Access Compliance Report

Public Rights-of-Way

(Curb Ramps)

Intersection ID: 10026802	Main Street: FOREST_POINT_BV	Cross Street: N/A	Location: NW
ADA ID: D9187F6940C9	Ramp Type: Perp	Initial Pass/Fail: Fail	Overall Compliance: No
Severity Score: 25			
Codes/Mitigation Info/Possible Solution		Field Measurements/Component Compliance

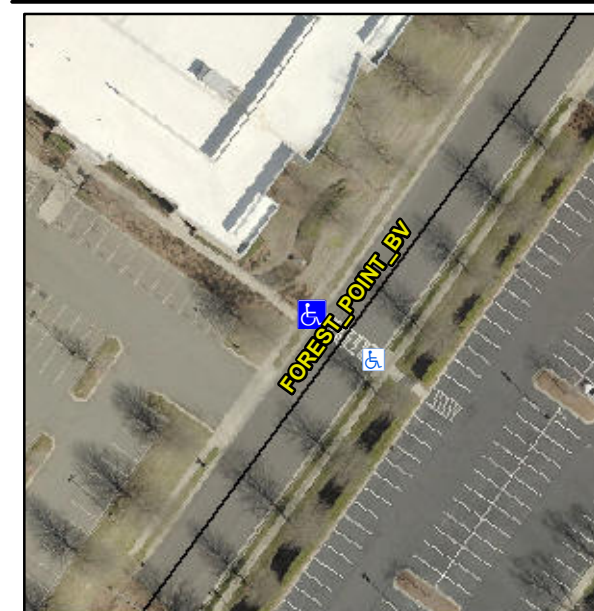
R304.2.2

Compliance	Description	Data	Compliance	Description	Data
N/A	Ramp Length (in)	50.0	No	Ramp Slope (%)	17.5
Yes	Ramp Width (in)	49.0	Yes	Ramp XSlope (%)	0.3
N/A	Flare Type LT	N/A	N/A	Flare Type RT	N/A
N/A	Flare Slope LT (%)	N/A	N/A	Flare Slope RT (%)	N/A
N/A	Flare Traversable LT?	N/A	N/A	Flare Traversable RT?	N/A
N/A	Landing Length (in)	N/A	N/A	DWS Provided?	N/A
N/A	Landing Width (in)	N/A	N/A	DWS Contrast?	N/A
N/A	Landing Slope (%)	N/A	N/A	DWS Length (in)	N/A
N/A	Landing X Slope (%)	N/A	N/A	DWS Full Width?	N/A
N/A	Landing Curb? (Y/N)	N/A	N/A	DWS Offset (in)	N/A
N/A	Shared Landing?	N/A			
N/A	Gutter Ponding?	N/A	N/A	Gutter Slope (%)	N/A
N/A	Gutter Lip Ht (in)	N/A	N/A	Gutter X Slope (%)	N/A
N/A	Painted X Walk1?	Yes	N/A	Painted X Walk2?	N/A
	X Walk 1 Direction	To SE		X Walk 2 Direction	N/A
N/A	X Walk 1 Width (in)	109.0	N/A	X Walk 2 Width (in)	N/A
	X Walk 1 Slope (%)	4.6		X Walk 2 Slope (%)	N/A
	X Walk 1 X Slope (%)	1.0		X Walk 2 X Slope (%)	N/A

Remove & Replace Entire Ramp.
